GROUP	MODEL
ELE	2024MY Sorento (MQ4a)
NUMBER	DATE
354	September 2024

TECHNICAL SERVICE BULLETIN

SERVICE ACTION: ICU FUSE LABEL REPLACEMENT (SA585)

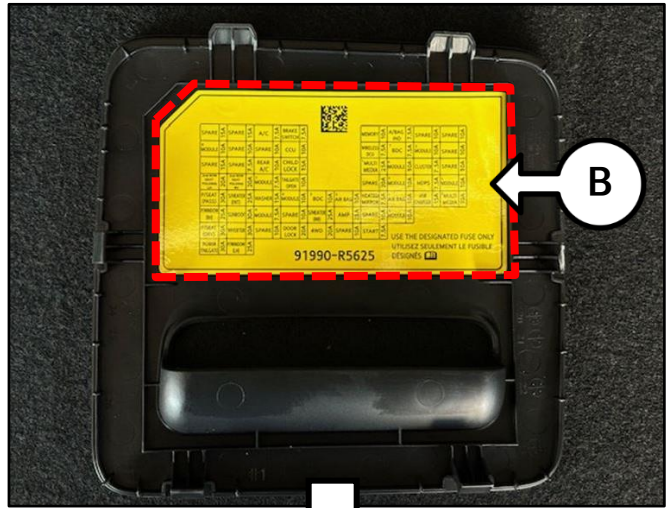
1. Locate the ICU fuse panel cover (A).

2. Remove the ICU fuse label (B).

Note: The 'old' label may **yellow** or **orange**.

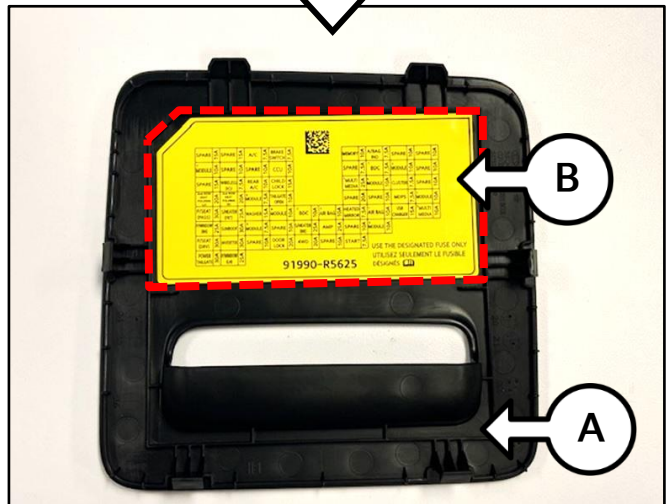
3. Install 'new' ICU fuse label (B).

4. Reinstall ICU fuse panel cover (A).
